# OVERLOT GRADING, POND SR4 & UTILITY CONSTRUCTION DOCUMENTS

## FALCON MARKETPLACE

ISSUE	DATE
1ST SUBMITTAL	6-20-17
RESUBMITTAL	8-13-18

SPILLWAY SECTION A2-A2  
NO SCALE

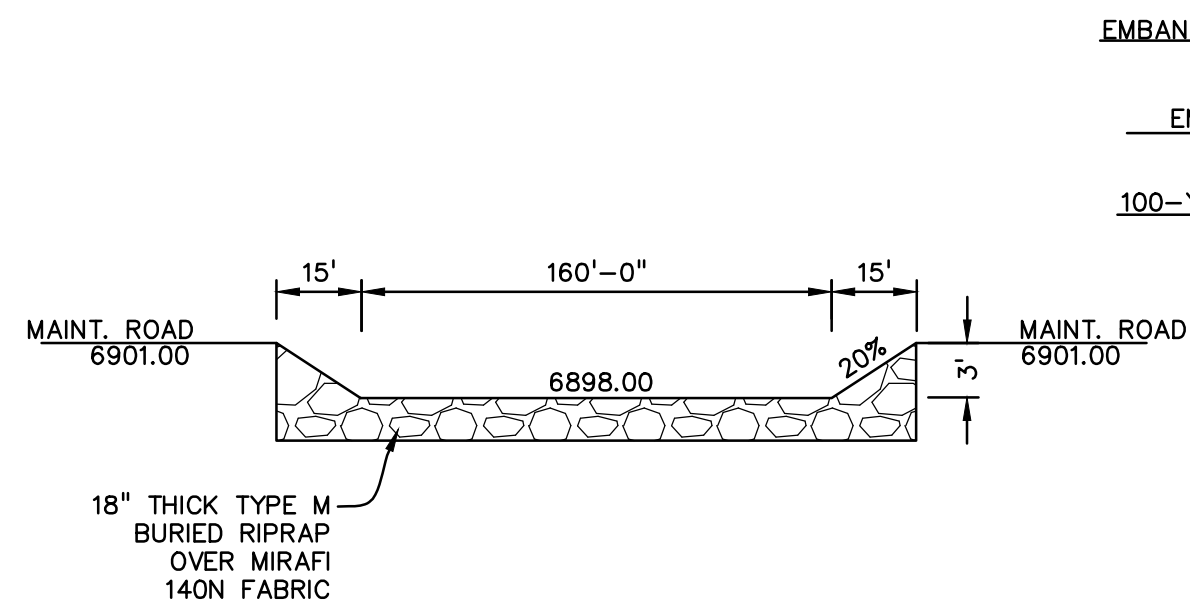
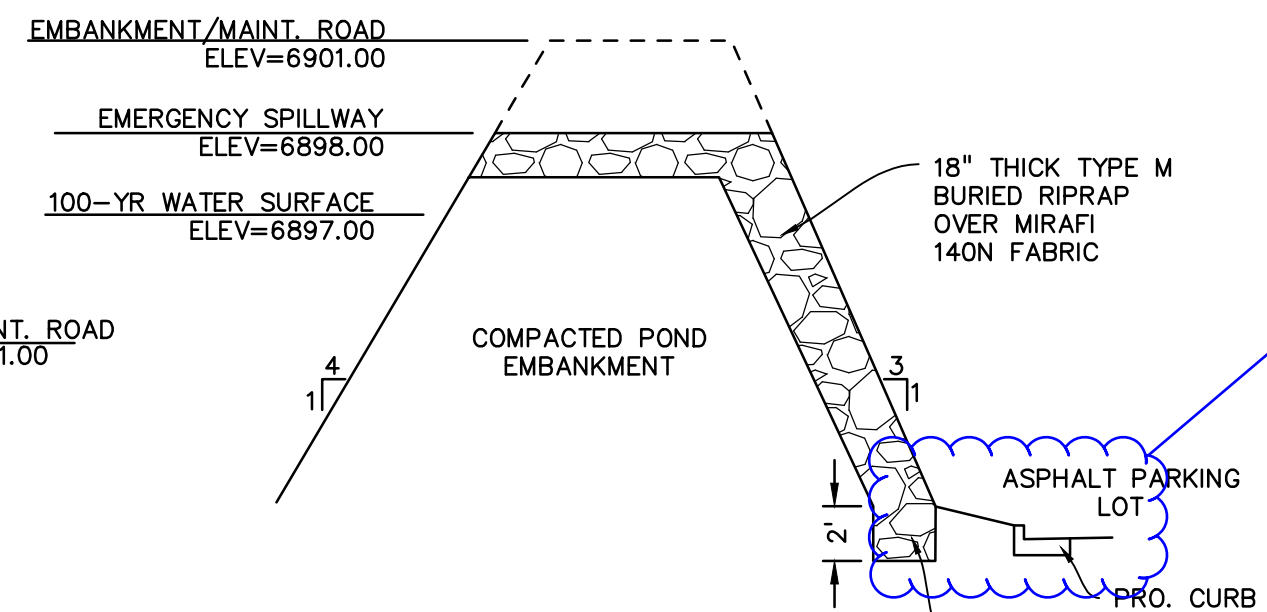
Provide specific details.

CONCRETE CHASE PLAN  
1"=10'

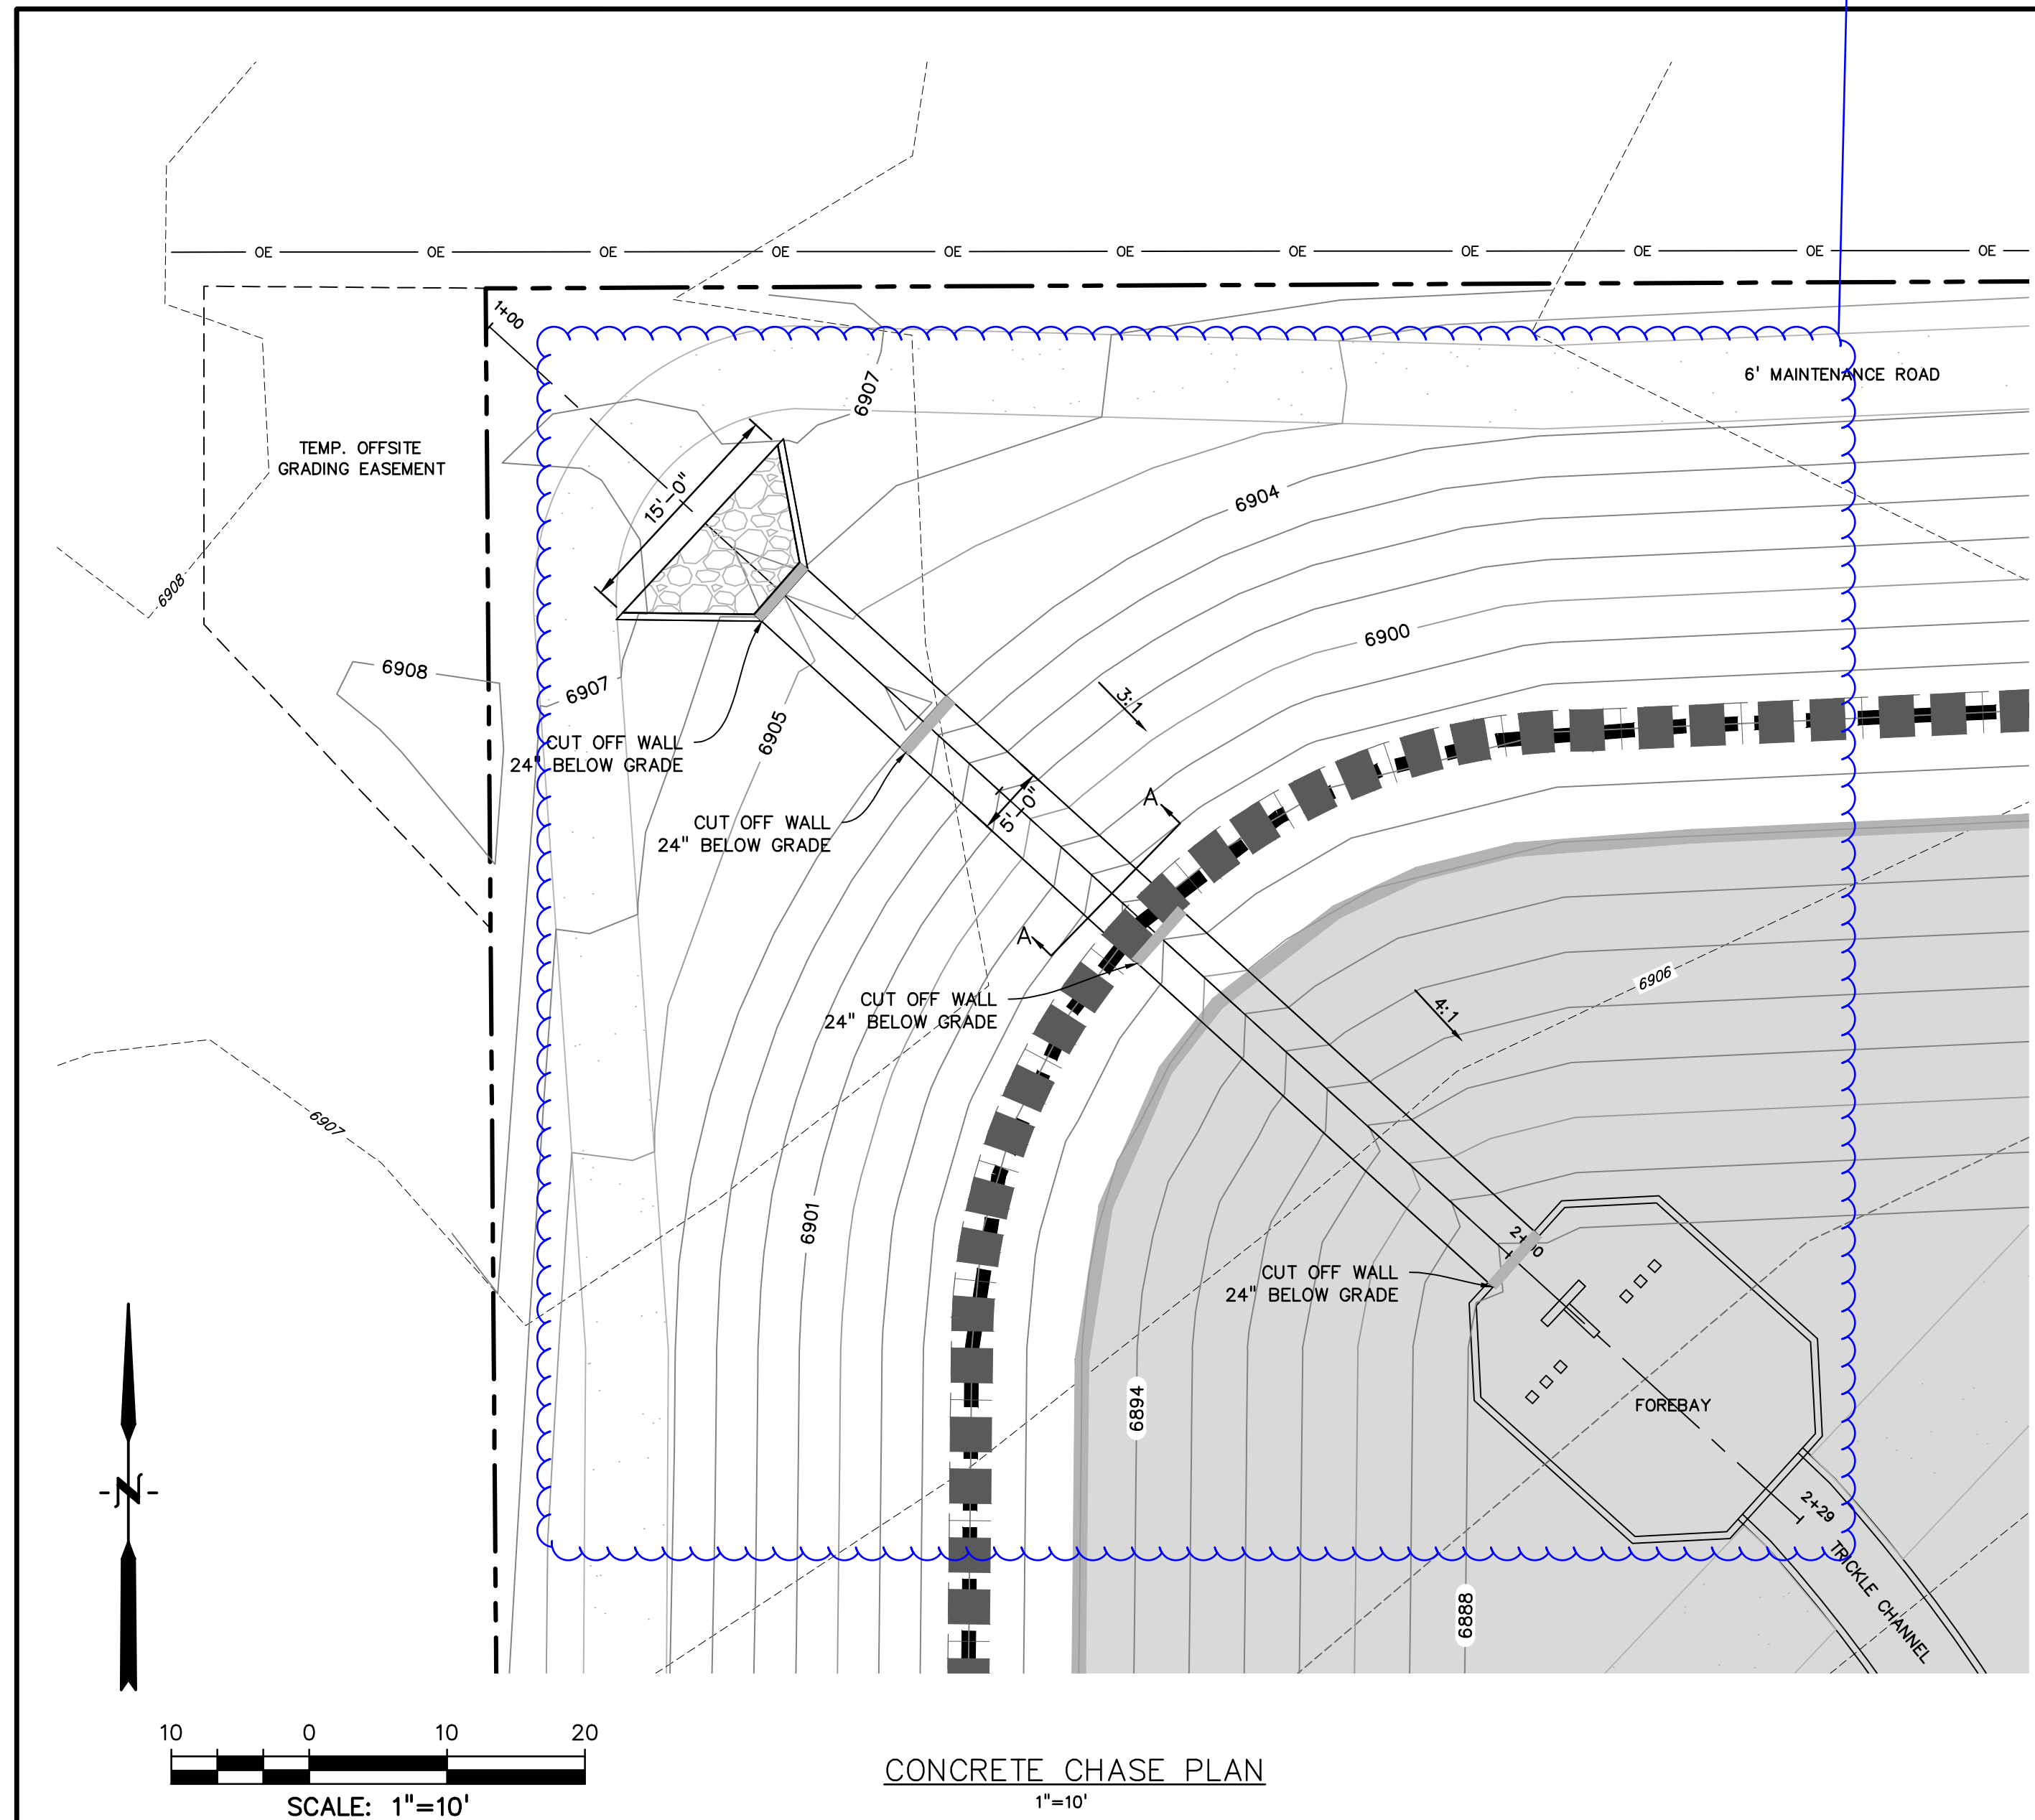
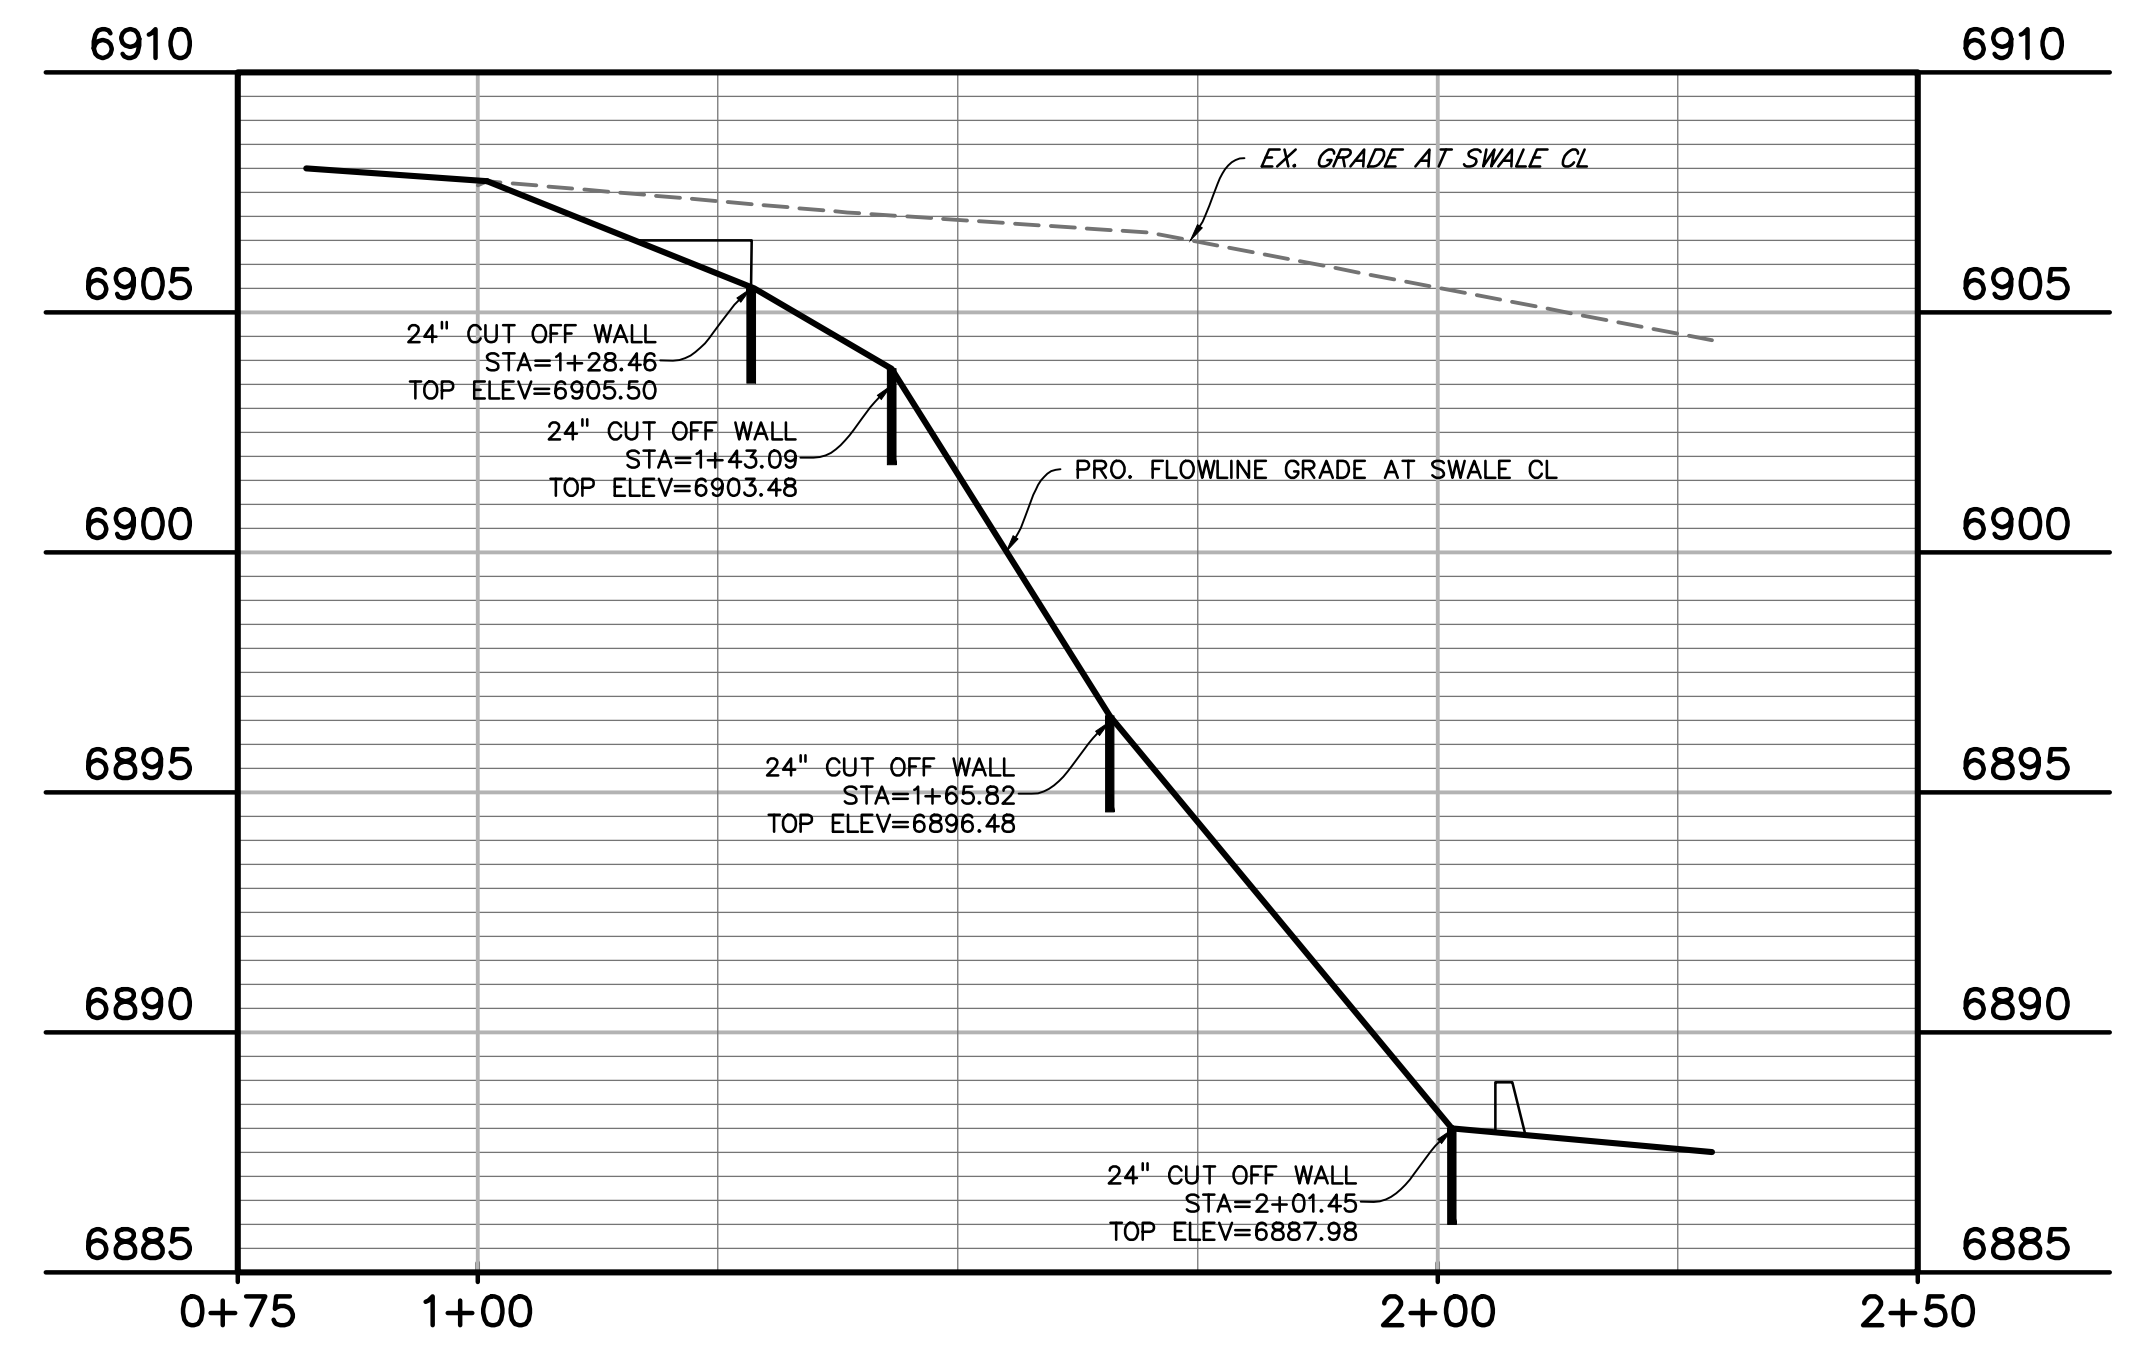
Reconsider this design concept - discuss with staff.
